# SERVICE BULLETIN

SB No. 68 Issue No. 5

**TITLE**
**CANOPY LATCH CORRECT OPERATION INSPECTION**
**CLASSIFICATION**

This Issue 5 is raised to add the following information:  
 High Rise Canopy Mod M736 dimension added to Fig. 1.

Fig 1

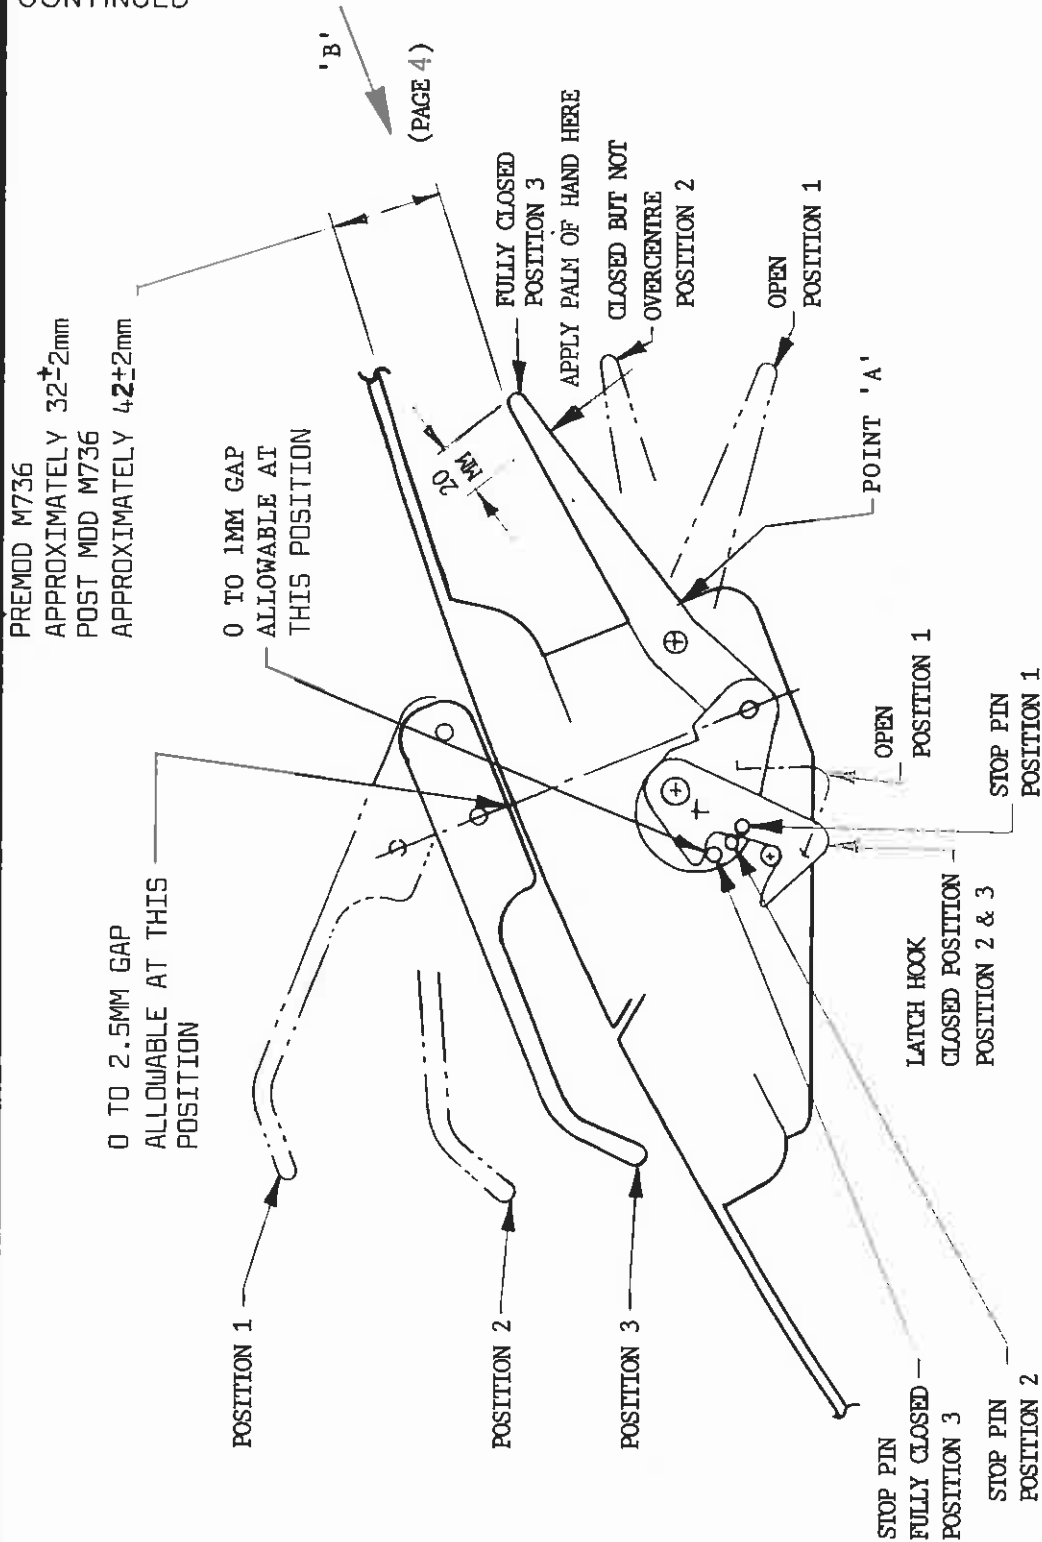
Fig. 1 page 2 shows 3 positions of the canopy mechanism:

Position 1 - Open/Unlatched

Position 2 - Latched but mechanism not over centre

Position 3 - Correctly closed, mechanism fully over centre.

- (i) Remove canopy mechanism and latch covers
- (ii) Close canopy fully. Ensure internal handle is in its correct position and external handle is in its correct position, ie touching bush or no more than 2.5mm gap. Fig. 1.

- (v) Check closure. By positioning palm of hand at point indicated, ref. Fig. 1, push up latch handle, which should close with reasonable resistance but without using excessive force.

FIG 2  
VIEW ON ARROW 'B' (REF FIG 1)

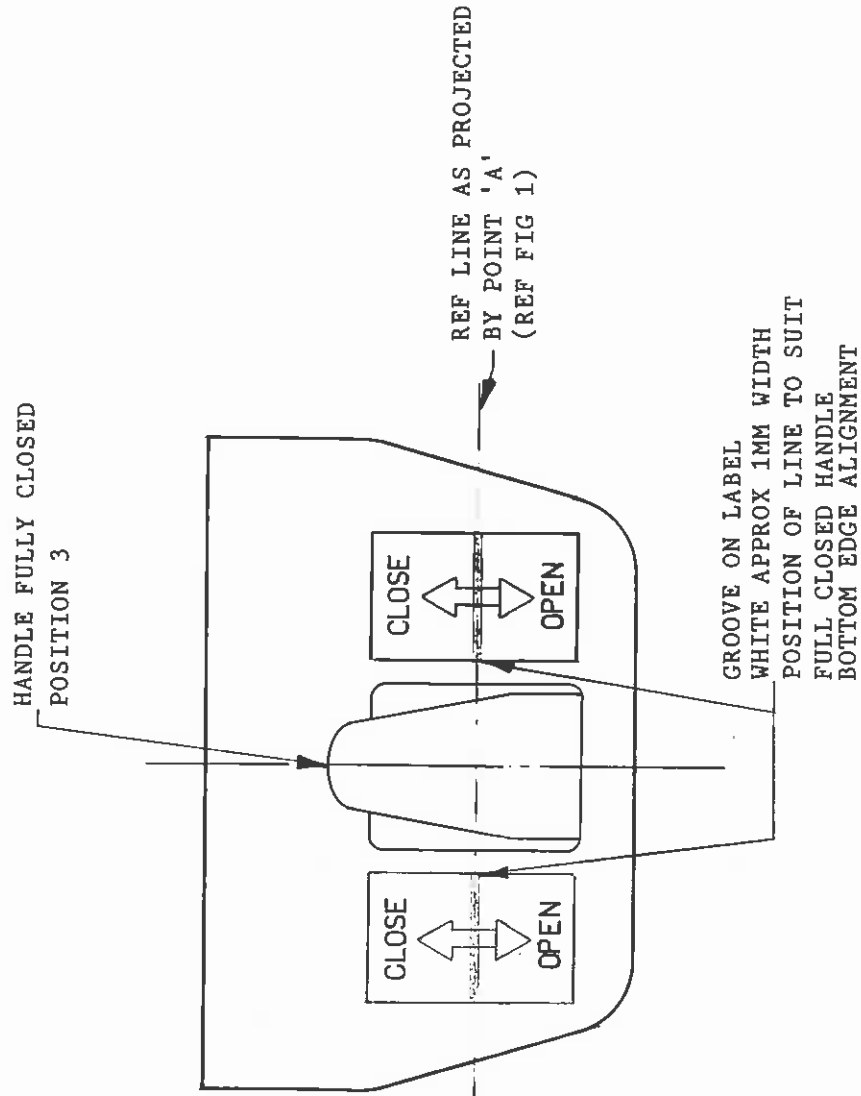
- (viii) When handle is fully closed, ie meets requirements of Fig. 1, mark a white line across both labels ref. Fig. 2 on line with handle lower surface (ie coincident with Point 'A' ref Fig. 1 & 2. The line may be obtained by running a hacksaw across both labels; a) deep enough to reveal white of label material or b) if base material is red, deep enough to hold white fill in wax, ie 0.25mm to 0.5mm.

When label is marked, it is to be identified in IPC Ref. Chapter 15 as Part No. T67M-17-351 Post Mod M666, Part No. T67M-17-319 to be annotated Pre Mod M666. Annotate Logbook Mod M666 incorporated.
- (ix) Providing the mechanism is correctly adjusted it should be obvious to the pilot that the latch mechanism has gone overcentre.
- (x) On completion of this SB, annotate Logbook SB68 complied with.
- (xi) Should a new canopy/seal be fitted, the latch mechanism inspection, as outlined in this Service Bulletin should be repeated up to 25 flying hours after installation.

FIG 3

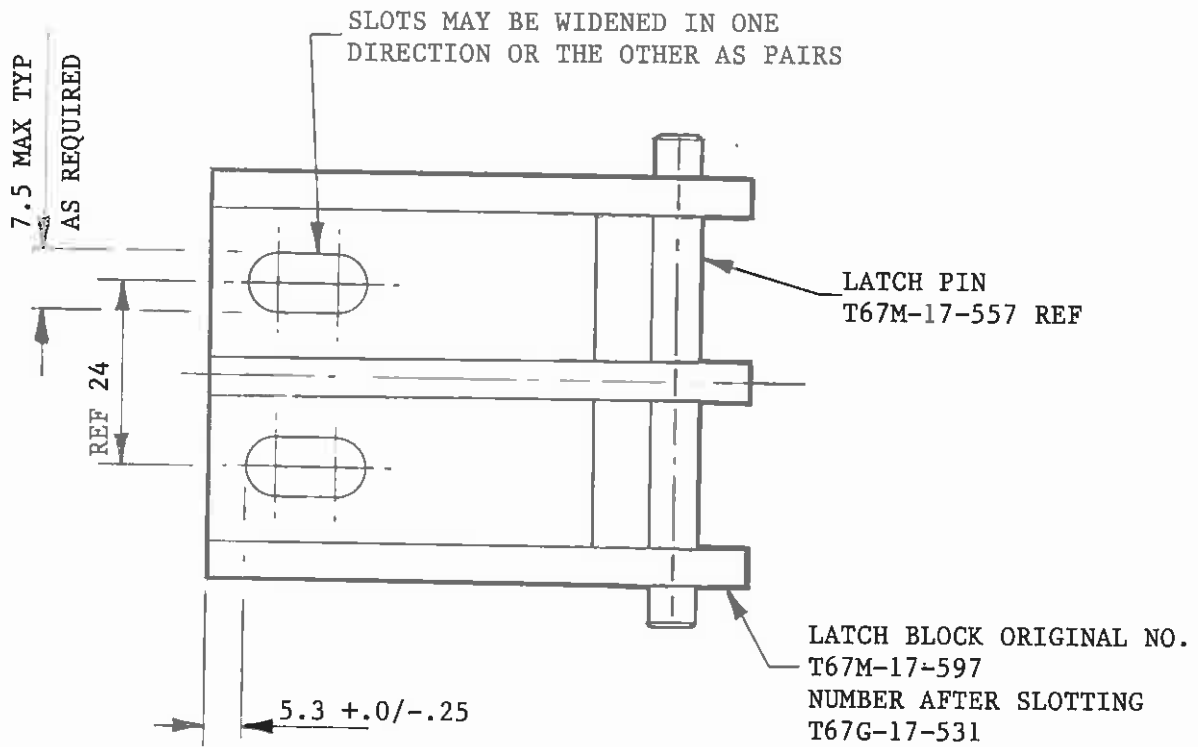
- (iv) If (ii) and (iii) cannot be met after adjustment, then it is acceptable to slot latch block Ref. Fig. 3. Suitably re-protect cut surfaces and re-identify block as Part Number T67G-17-531 Post Mod M713B. Annotate Logbook accordingly.
